Site Plan Review Committee (SPRC)
Staff Report for
685 & 701 N. Glebe – Ballston Macy’s Site

Ballston Macy's Site (SP #193)
685 & 701 N. Glebe Road
(RPC#s 14-059-038, -044, -045)

DATE: November 7, 2022
PLACE: SPRC Meeting #2 – Hybrid

Graphic illustrating ground floor, including loading and parking entrances, from the applicant’s draft multimodal transportation assessment addendum, August 2022.

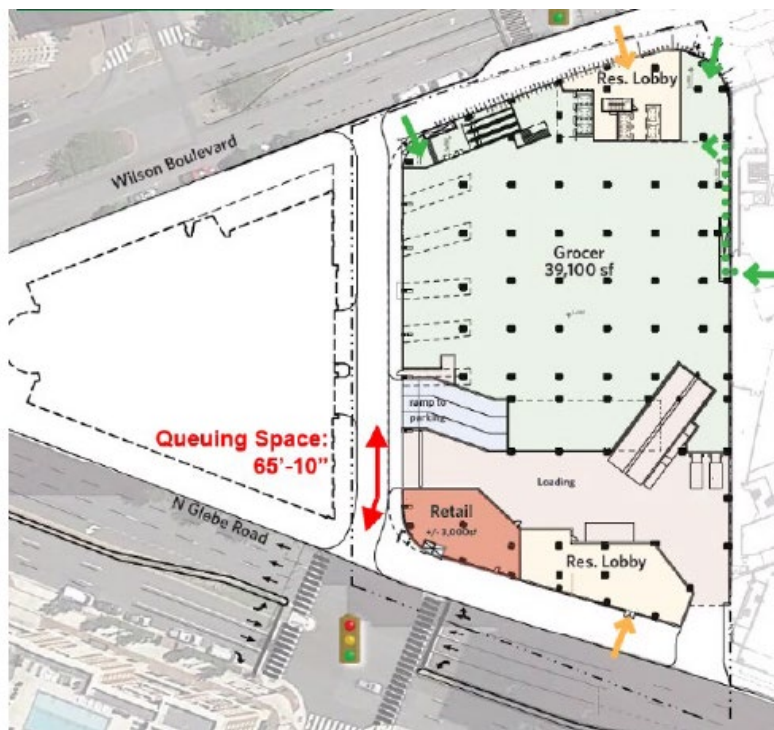
DES transportation has expressed some concerns regarding the project’s impacts on traffic operations and safety. Specifically, DES expressed concerns in the four following areas:

Impacts of the proposed left turn from southbound Glebe Road into the site. The length of the left-turn pocket may not be of sufficient capacity for the potential amount of traffic expected. This may cause impacts to traffic operations and traffic safety.

Impacts to pedestrian safety: The new left-turn pocket may impact pedestrian safety because of the introduction of a new vehicular movement that did not previously exist. Reduction of the median width may negatively impact pedestrian safety. Other new traffic movements, as well as increased traffic volumes due to the proposed new use (grocery store) may negatively impact pedestrian safety.

Location of garage entry and vehicle queuing: DES expressed concern that the location of the garage entry on the private street was too close to the sidewalk (and Glebe Road), and may not be set far enough back from the public street and sidewalk to ensure that there would not be vehicular backups onto the sidewalk and the public right-of-way, creating conflicts.

Loading issues: the introduction of large (53’ long) trucks, unloading perishable merchandise three to five times per day, into the site, raised concerns among staff. Initial concerns were with respect to the location of the loading dock entry along Glebe Road, interrupting a continuous street wall and a streetscape, losing an opportunity for an enhanced pedestrian experience. Further, transportation staff raised concerns about the way large trucks were required to enter the loading dock from Glebe Road from a far lane, crossing over two lanes of traffic. Finally, staff expressed concerns about large trucks exiting the site onto the private street, swinging into the pedestrian zone.

For each of the above operational concerns, the applicant worked with DES technical staff, in some cases revising their plans to accommodate changes to the plan. In other cases, the applicant and County staff resolved issues through agreeing upon mitigation measures to be put into place to ensure compliance or to minimize potential negative impacts. In other cases, additional analysis has been provided to demonstrate the effectiveness of mitigation measures or other traffic measures that will bring all of the applicant’s proposals within the range of acceptability to the County.
